LINCOLN/LANCASTER COUNTY PLANNING STAFF REPORT

for September 13, 2006 PLANNING COMMISSION MEETING

PROJECT #: Use Permit #06005 - Yankee Hill Plaza

PROPOSAL: To allow 216,000 square feet of office and commercial floor area on a site proposed for annexation and rezoning to B-2.

YANKEE HILL PLAZA
USE PERMIT SITE PLAN EXHIBIT
LINCOLN, NEBRASKA

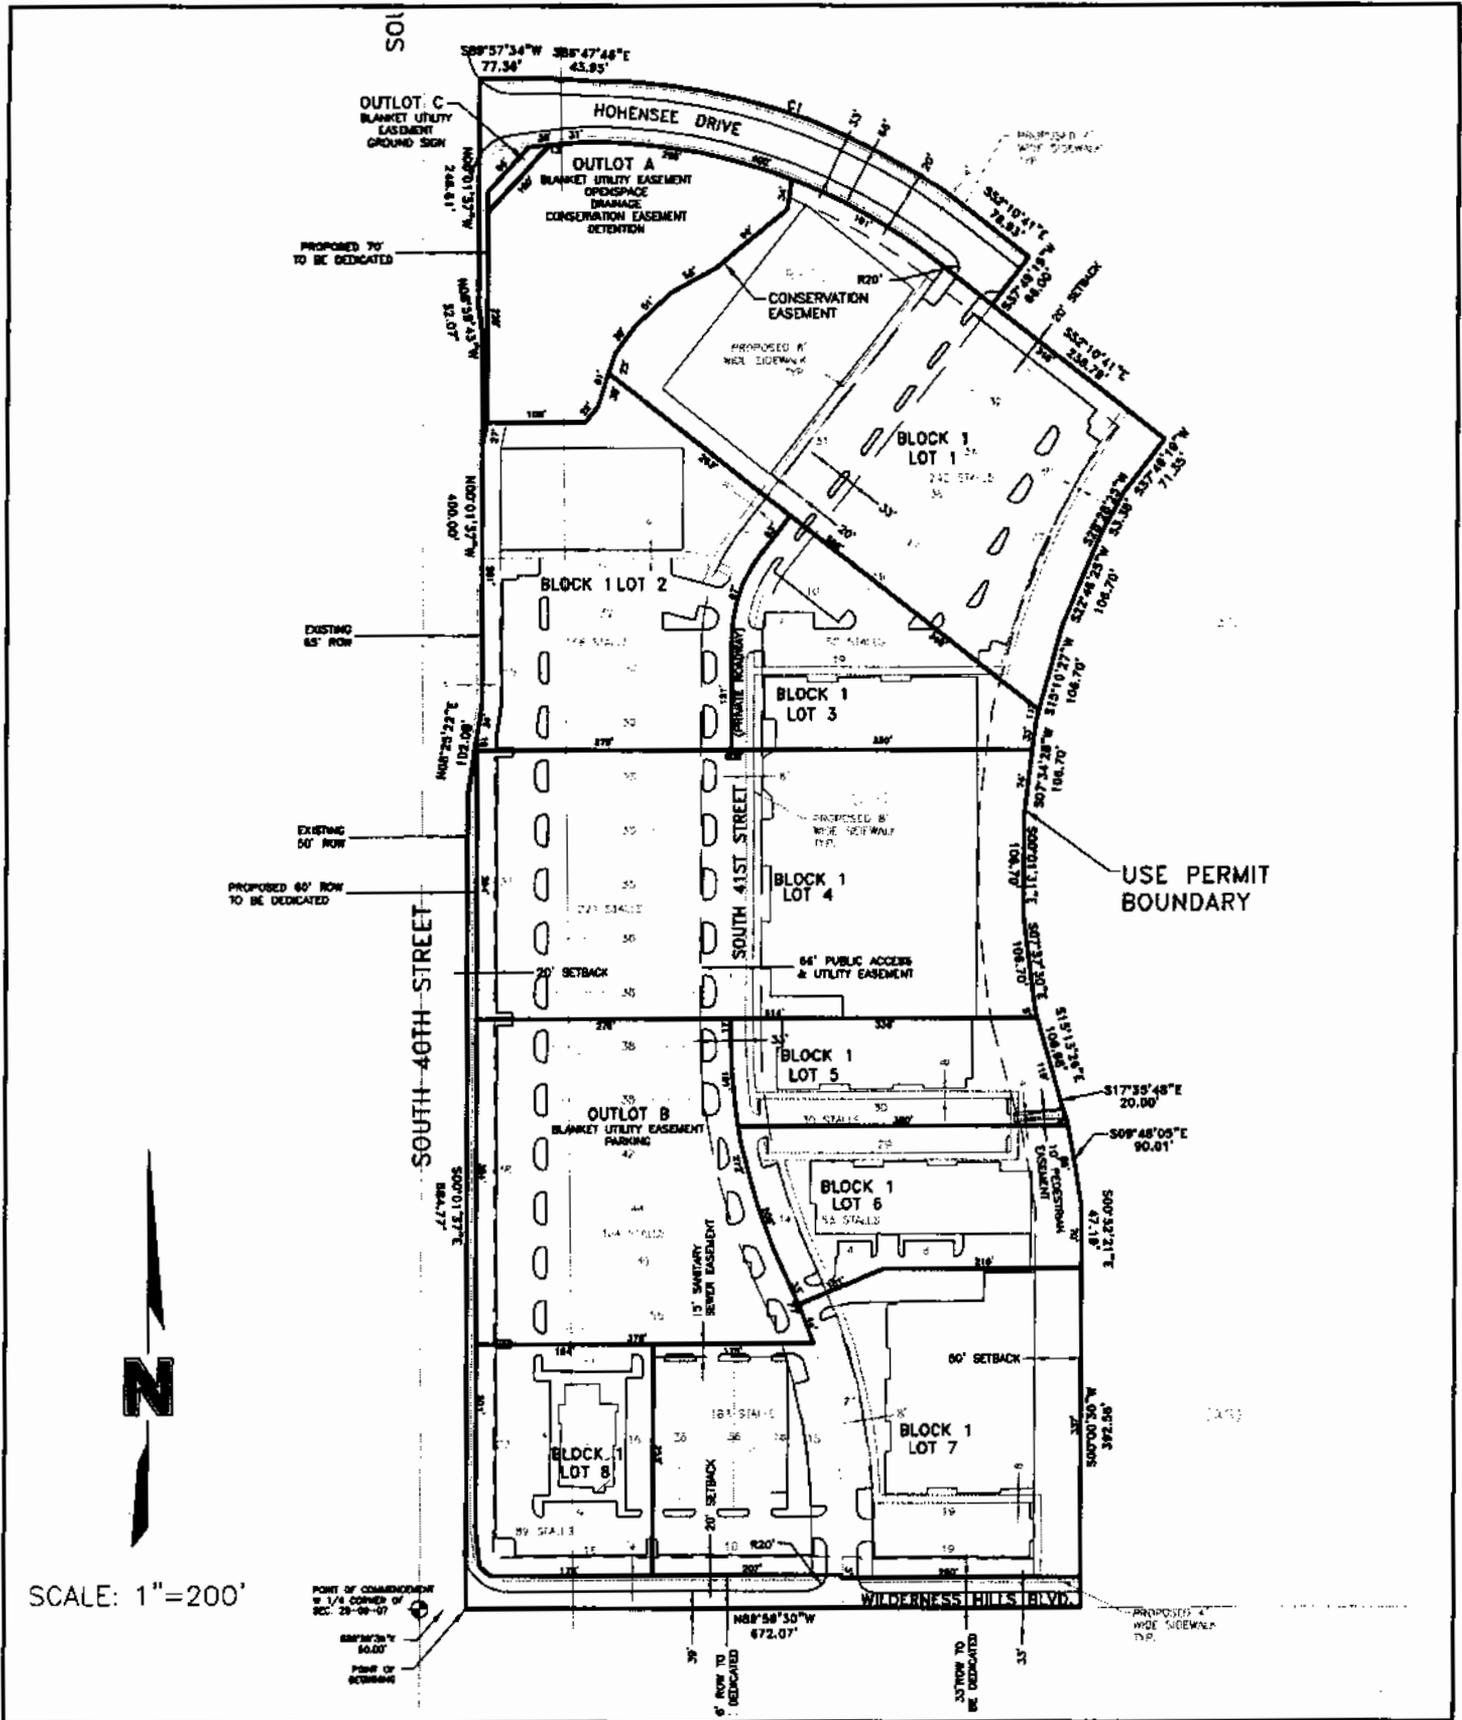
5. A waiver to allow lots without frontage to a public street or private roadway is also requested. The center is laid out so that access to all lots is provided by a common access easement through the middle of the site, typical for a center such as this. This driveway is misidentified on the site plan as a private roadway and mislabeled as South 41st Street. It should be merely shown as a common access easement.

6. Hohensee Drive is shown only extending as far east as the drive through the center. It must be shown extending to the east boundary of the site.
7. Pedestrian circulation would be enhanced if the building on Lot 8 and the parking lot east of it changed places. Putting the buildings closer together and facing one another helps make the center more pedestrian oriented and accessible to customers.

8. Public Works notes that the grading and drainage plan is inadequate and must be revised. It is also noted that Public Works has not accepted the traffic study and that it must be approved prior to project approval. Based upon the traffic study submitted, Public Works is indicating that South 40th Street may need to be improved to

9. The fire hydrant plan is not adequate and must be revised. Fire protection must be provided per code requirements or building permits cannot be issued.
10. Several minor corrections to the plans and General Site Notes are required, and they are included as recommended conditions of approval.

- 2.1.1.6 Show Hohensee Drive extended to the east boundary of the use permit.
 - 2.1.1.7 Delete the labels South 41st Street and private roadway on all sheets including street cross-sections, and show a common access easement instead.

- 2.1.1.8 Add the waiver to allow lots not adjacent to a public street or private roadway to the list of waivers on Sheet 1 of 5.
 - 2.1.1.9 The surveyor's certificate must be signed.

- 2.1.1.10 Show fire hydrants to the satisfaction of Fire Prevention.
 - 2.1.1.11 Show utility easements to the satisfaction of LES.
 - 2.1.2 Revise the grading and drainage and utilities plans to the satisfaction of Public Works and Utilities.
